Wisconsin Department of Transportation

Proposal #31: 8820-00-70
Frederic – McKinley
STH 35 to Bass Lake Lane
STH 48
Polk County

This is Addendum No. 01, which provides for the following:

ADDENDUM NO. 01

PROJECT NO: 8820-00-70	HWY: STH 48	COUNTY: POLK	TYPICAL SECTIONS	SHEET 7	E

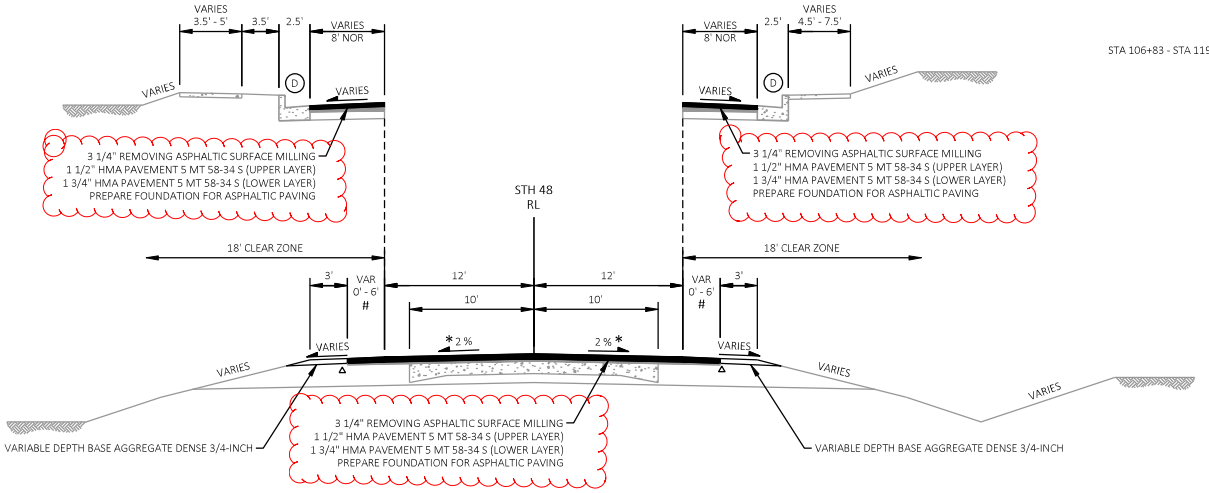
Revised Plan Sheets	
Plan Sheet	Plan Sheet Title (brief description of changes to sheet)
7, 8, 9	Revised typical sections to change the HMA Pavement type throughout the project and changed the lower layer for the guardrail widening areas to Asphaltic Surface.
85, 86	Revised HMA Pavement and Asphaltic Surface quantities. Revised HMA Acceptance Table.
